APPEARANCE REVIEW BOARD

AGENDA ITEM 3 225 S. GARLAND AVE. HYATT PLACE HOTEL

ARB2014-00071

Courtesy Review for a new 13-story Hyatt Place Hotel with 205 rooms, 4,312 s.f. of meeting space and a 461 space integrated parking garage.

EAST ELEVATION

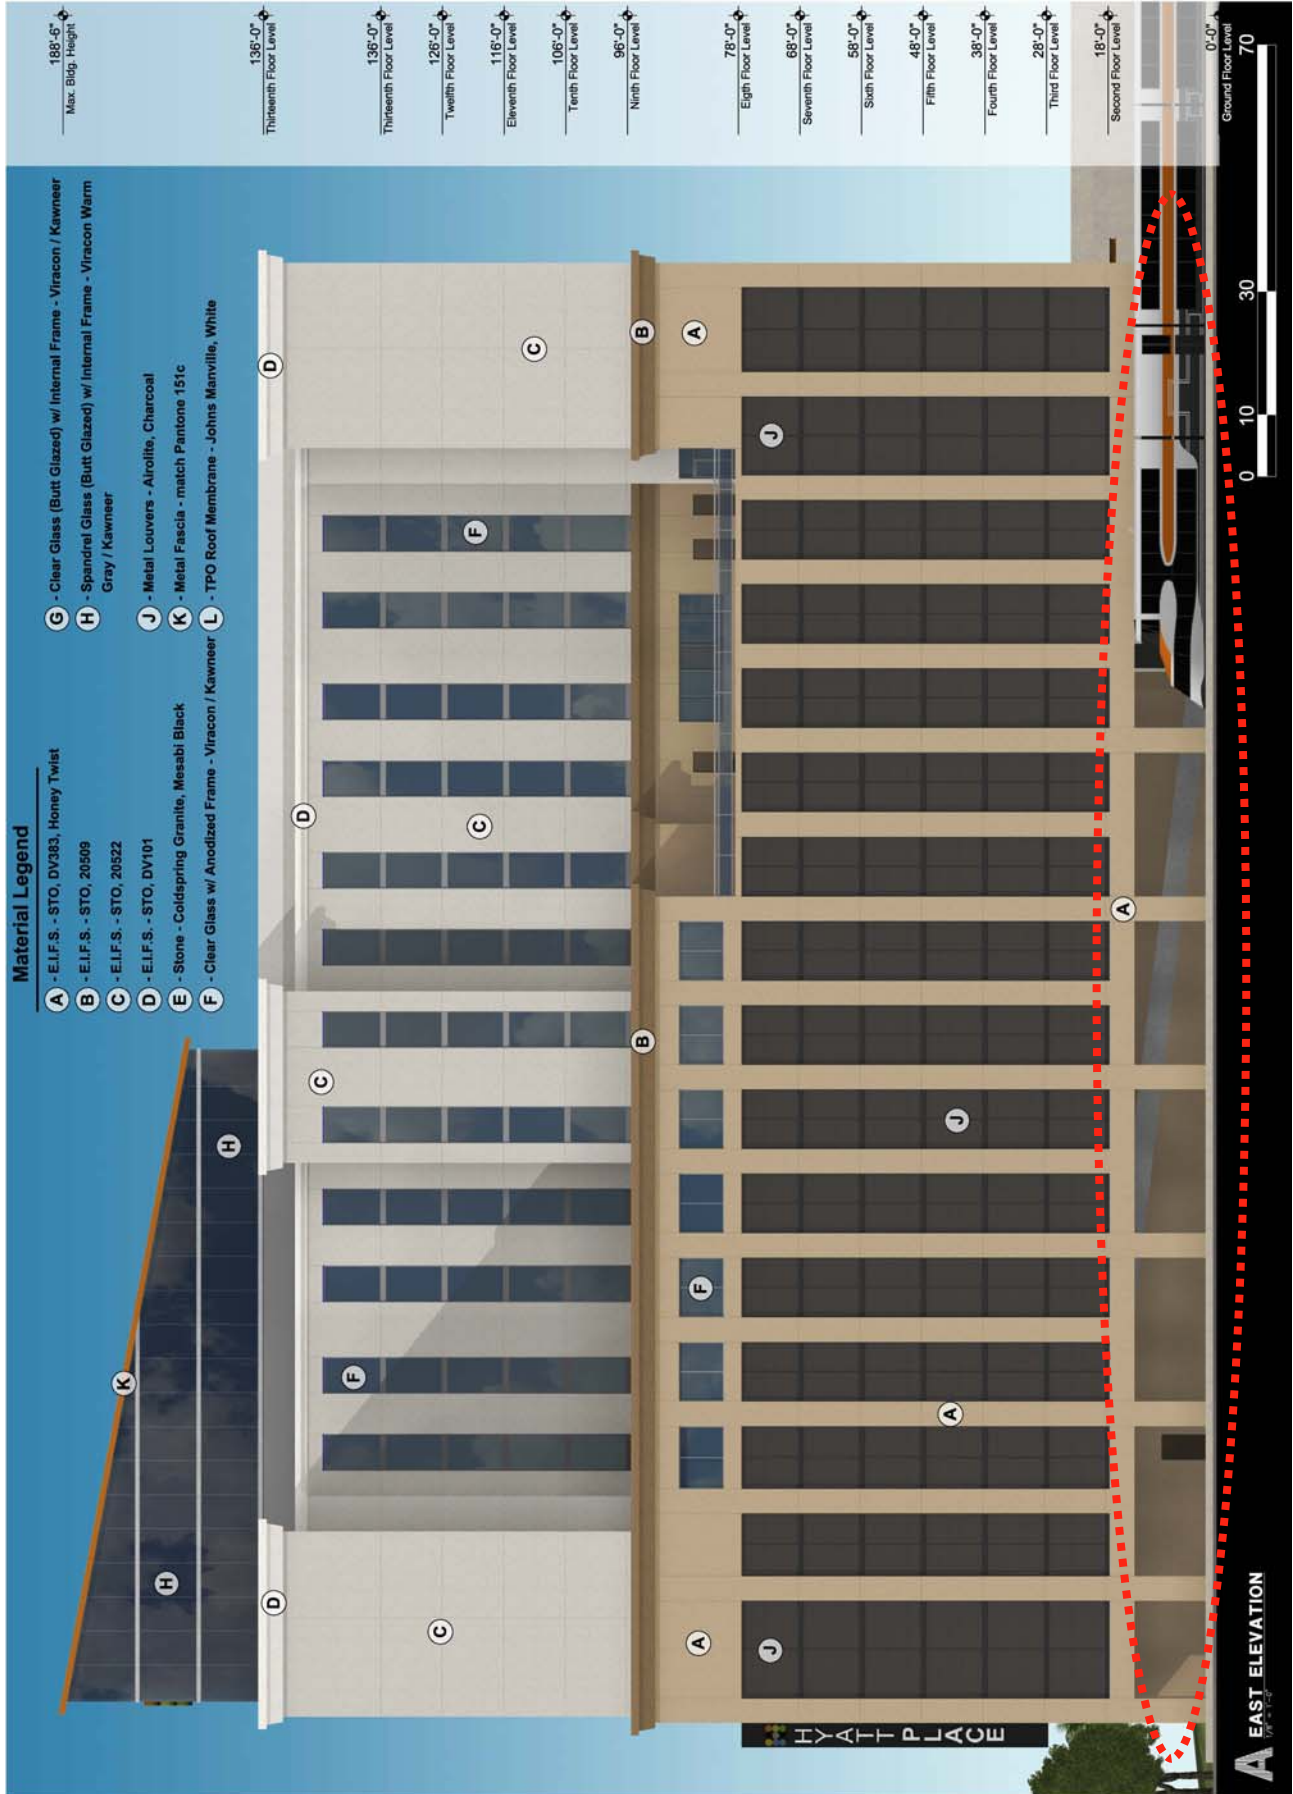
Add water table base;
Clad columns in granite
